**Edinburgh Tram Network Infracore  
Development Workshop Report: Trackform**

# Development Workshop Report Trackform

## **DEVELOPMENT WORKSHOP REPORT : TRACKFORM**

This document, no BSC/25.1.201/DWR/TR001, is the report of the Development Workshop for Trackform.

## 2. Embedded Trackforms – Rheda CITY “C” (R≥100m)

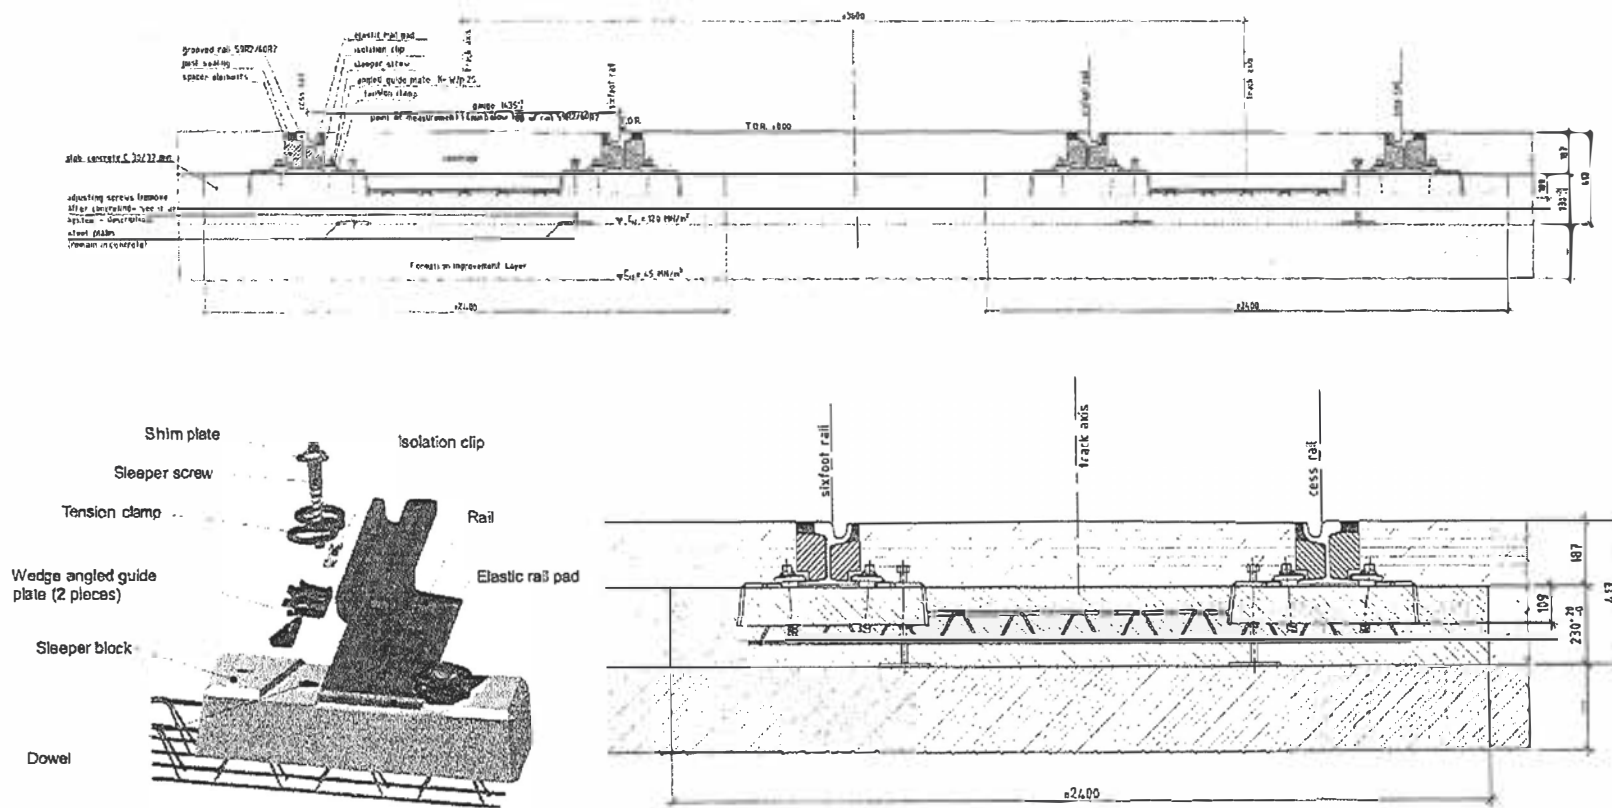
2.3.1 Trackform : Infraco Proposals for embedded track are contained in Schedule 30, section 3.1. 1. Rheda City track, in two variants (City –C and City – D) is proposed. One of the attributes of this proven track system is the use of resilient pads under the rail foot which provide an overall rail stiffness in service of 60MN/m. This value is selected to provide an effective compromise between maintainability/serviceability of the track-road surface joint and vibration damping.

The reference design is based on a track stiffness of 30MN/m, which satisfies the requirements of the Project Noise & Vibration Policy in terms of ground transmitted vibration without the need for additional mitigation, but is not compatible with the use of Rheda City trackform and appropriate maintainability performance.

It is likely that the higher levels of ground transmitted vibration resulting from the use of a stiffer trackform will require additional vibration damping or isolation measures to be provided within the trackform. Outline proposals for a floating track system are identified in Schedule 30, section 3.1.1.6.

An instruction is required for SDS to investigate the consequences of the change of the trackform, identify any areas of non compliance with the Project Noise & Vibration Policy limits and design specific floating track mitigation measures as required.

In this case an instruction to BSC to provide and install this floating track mitigation is necessary.

## 4. Ballasted Track – BAM

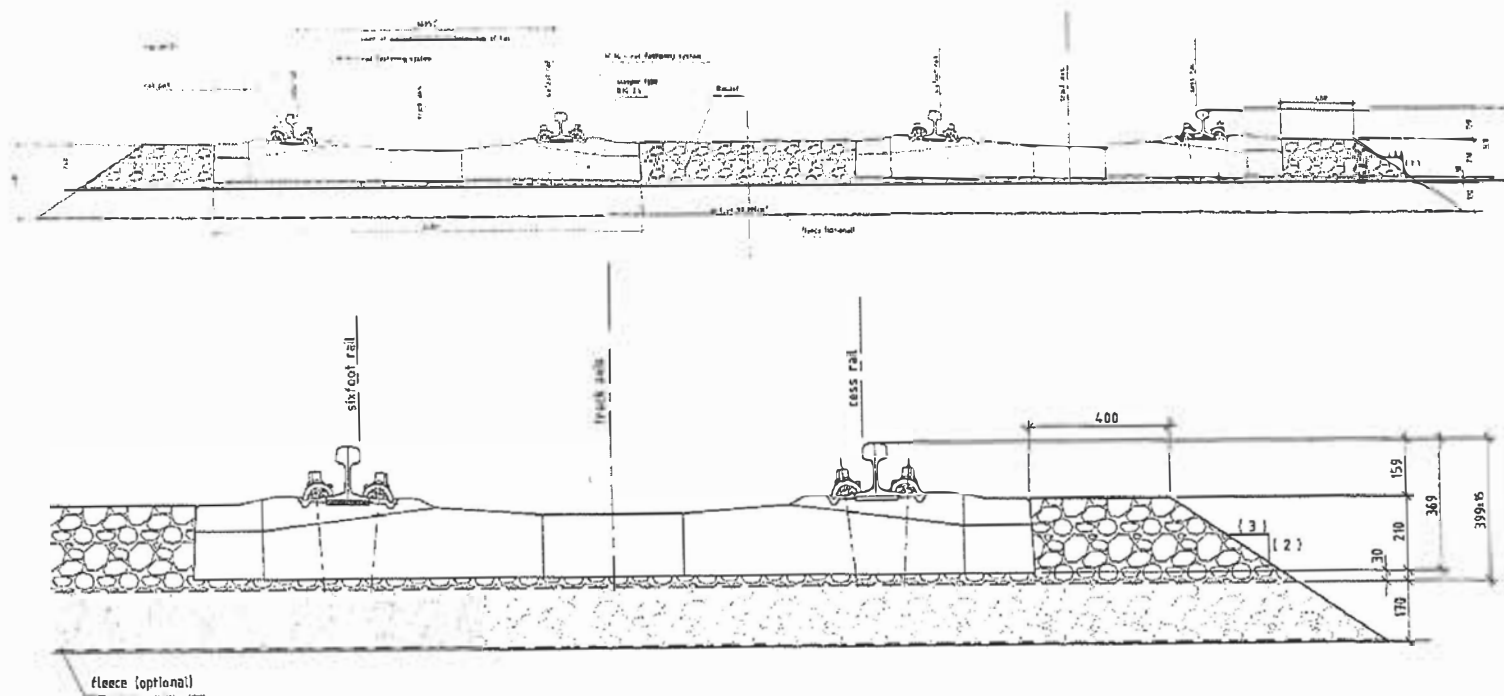
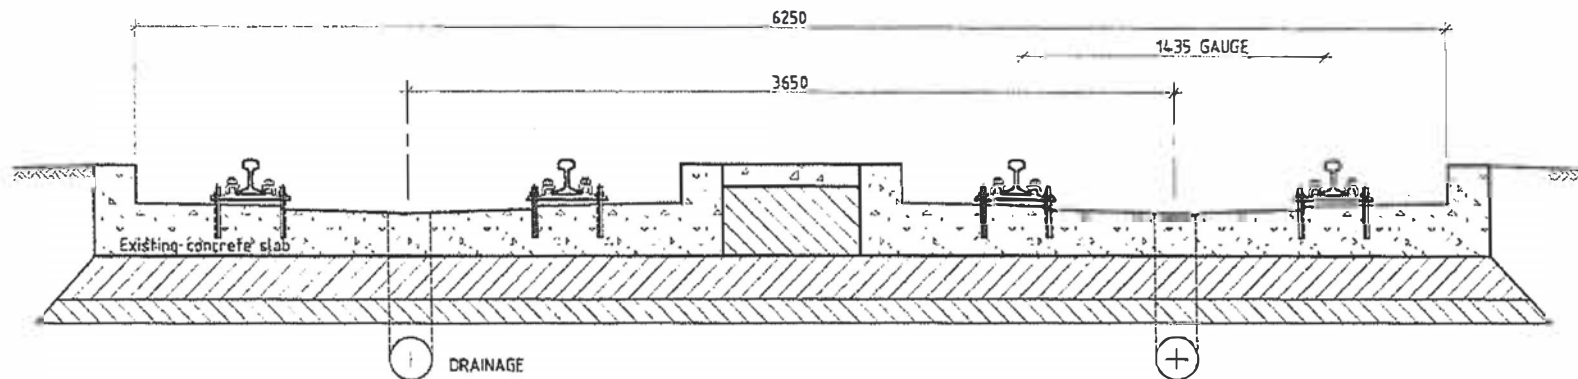
SDS trackwork design identifies a ballast shoulder width for straight tracks and horizontal radii larger than 2000 m of 375 mm. For radii of 2000 m and less, 450 mm ballast shoulder width is identified. SDS Design includes a very light twin block sleeper. It is not clear on which basis the ballast shoulder width is defined.

BSC (Siemens) proposal includes a much heavier mono block sleeper, and the corresponding ballast shoulder width is 400 mm. Standard sleeper distance is 750 mm in horizontal curves below 400 m the sleeper distance will be reduced to 600 mm.

The misalignment is the different dimensions of ballast shoulder width.

Package No.:		Package Title: Trackform		Status: IFC	Responded by:
Issued by: BSC				Date of Response:	
Date of Comments: 19 Nov. 2008			Doc. no.: DWRC-002		Ver. 2
No.	Doc. Ref.	Comment	Acción	Response	
1.5		<p>SDS trackwork design identifies a ballast shoulder width for straight tracks and horizontal radii larger than 2000 m of 375 mm. For radii of 2000 m and less 450 mm ballast shoulder width is identified with 450 mm. SDS Design includes a very light twin block sleeper. It is not clear on which basis the ballast shoulder width is defined.</p> <p>BSC (Siemens) proposal includes a much more heavier mono block sleeper, chosen ballast shoulder width is 400 mm. Standard sleeper distance is 750 mm in horizontal curves below 400 m the sleeper distance will be reduced to 600 mm. BSC(Siemens/BAM) has to provide evidence that the ballast shoulder is sufficient.</p>	Siemens/ BAM

Confirmation of no objection to the proposed ballast shoulder dimensions will be sought from Tie as part of System design development. This resolution is not part of the Development Workshop Process.

Modification of existing drawings to incorporate Infraco trackform proposals (ie cross sections), will include ballast shoulder dimensions. No additional instruction is required.

## 5. Guided Busway (1) BSC Proposal

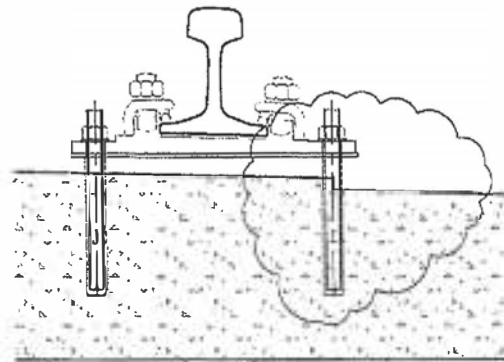
The Infraco Proposal for track on the Guided Busway is 'Direct Fixation Fastening track' direct fixed on top of the existing guided busway as noted in Schedule 30, section 3.1.2 (see sketch Guided Busway (1) of presentation at Appendix 2 of this document).

It is possible that the structural condition and construction tolerances of the existing Guided Busway are not suitable for direct fixation track. The possible misalignment here is the confirmation that the guided busway is suitable to carry the Direct Fixation Track.

1.21		<p>BSC originally offered 'Direct Fixation Fastening track' direct fixed on top of the guided busway (see sketch Guided Busway (1) of presentation).</p> <p>INFRACO agreement includes assumption as written below:                      "The existing guided bus way is assumed to be capable for a Tram system in terms of alignment, tolerances and bearing capacity. Adjustments in terms of grouting of the structure at its surface may become necessary to meet the alignment criteria. The selection of grouting material will be subject to approval. It is assumed that coring of fixings into the guided bus way concrete is possible."</p> <p>Based on the as-built documentation and our own on-site investigation we assume in the meantime, that the guided busway doesn't meet these defined requirements. Two options are possible now:                      Following further on the DFF solution than an improvement of the guided busway is necessary by preparing an additional concrete slab on top of the guided busway, DFF should than fixed on the concrete slab (see sketch Guided Busway (2) of presentation).                      Alternatively the guided busway could be fitted with Rheda City ((see sketch Guided Busway (3) of presentation)                      Both solutions are associated with additional costs compared to the INFRACO</p>	BSC

In abeyance, pending review of Guided Busway construction. To be resolved in a future issue of this report.
